1992 Corvette: Service Bulletin: Harsh 1-2 Upshift

Subject: HARSH 1-2 UPSHIFT INSTALL SERVICE PACKAGE

Bulletin Number: 92-318-7A - (09/15/1992)

TRANSMISSION APPLICATIONS: SUBJECT: 1992 HYDRA-MATIC 4L60 Harsh 1-2 Upshift ;Install Service Package

CONDITION (Figure 1):

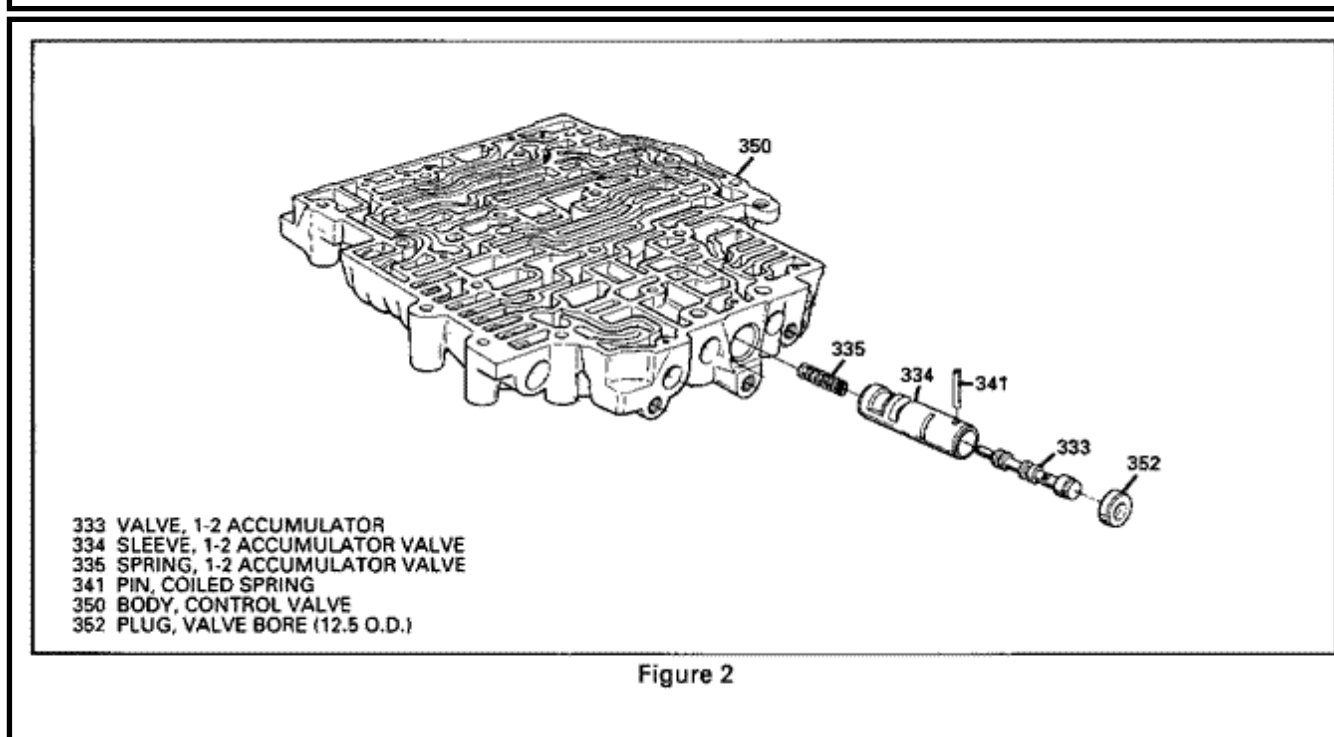
Some vehicles equipped with a 1992 HYDRA-MATIC 4L60 transmission built between Julian Date 061 (March 1, 1992) and Julian Date 171 (June 19, 1992) may experience a harsh 1-2 upshift. NOTE: Once the transmission is brought to operating temperature, the condition may not be able to be reproduced until a "cold soak" (overnight) is performed.

The above condition may be caused due to a tapered 1-2 accumulator sleeve. The tapered bore may cause the 1-2 accumulator valve to stick in the bottom of the bore.

CORRECTION (Figure 2):

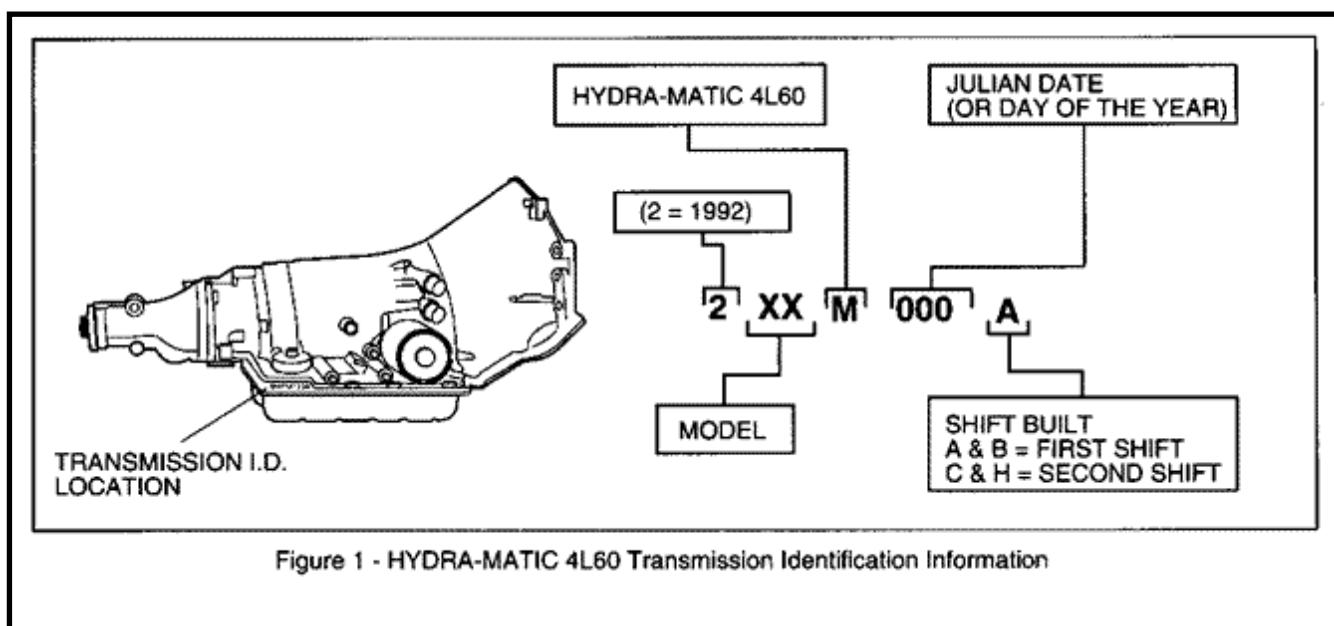
To improve the 1-2 shift, install the service package listed in this bulletin. A 1-2 accumulator valve and 1-2 accumulator valve sleeve (which, normally, is not serviceable) is included in the package.
